UNITED STATES PATENT AND TRADEMARK OFFICE

10/549,421

Office Action Summary	Application No. 10/549,421	Applicant(s) MELKER, JEREMY S	
	Examiner ERIN COLELLO	Art Unit 3734

DETAILED ACTION

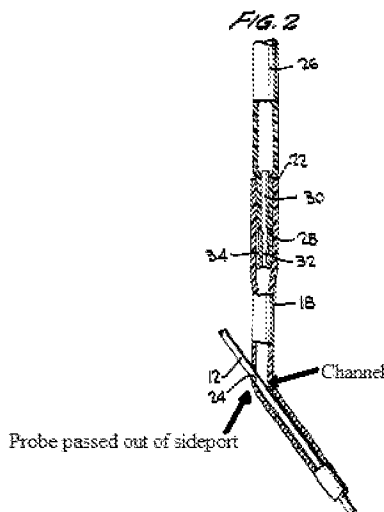
Regarding claim 1, Martinez discloses a probe (Figures 1, 2 and 3, (18)) useful in inserting a lacrimal stent comprising a proximal end and a distal end, said distal end being tapered to facilitate entry into a puncta of a patient (Column 3, Lines 39-41; Figure 3, (20)) wherein said probe comprises a channel (Figure 2 see below) extending from said distal end to a sideport on said probe positioned between said proximal end and said distal end. (Figure 2, (24))

Regarding claim 3, Martinez discloses a probe (Figures 1, 2 and 3, (18)) useful in inserting a lacrimal stent comprising a proximal end and a distal end (Column 3, Lines 39-41); said distal end being flexible and comprising a blunt tip (Figure 3, (20); Column 4, Lines 20-23) wherein said probe comprises a channel (Figure 2 see above) extending from said distal end to a sideport on said probe positioned between said proximal end and said distal end. (Figure 2, (24))

FIG. 3

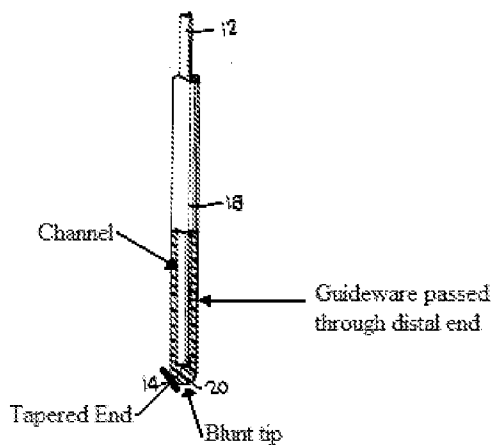
Regarding claim 7, Martinez discloses a method for inserting a lacrimal stent comprising inserting a tapered probe into a puncta of a patient to dilate said punta to a desired opening size (Column 3, Lines 39-41); said tapered probe comprising a rigid distal end, a proximal end, and a channel (Figure 3 see below) extending from said distal end to a sideport between said distal end and said proximal end of said tapered probe (Figure 2, (24)); passing a guidewire (Figure 3, (12); Column 4, Line 15) comprising a distal end and a proximal end through said tapered probe such that said distal end of said guidewire is passed through said sideport (Figure 2 see above; Figure 3 see below) into said puncta, and positioned in the patient's lacrimal apparatus at a

Martinez fails to disclose that the guidewire is passed out of the tapered probe.

However, Becker teaches a probe where the guidewire is passed out of the distal end of a tapered probe (Figure 2, (34); Column 7, Lines 19-20).

It would have been obvious at the time the invention was made to modify the probe so that the guidewire passes out of the end of the probe since such a modification allows the guidewire to remain in place after the probe is removed
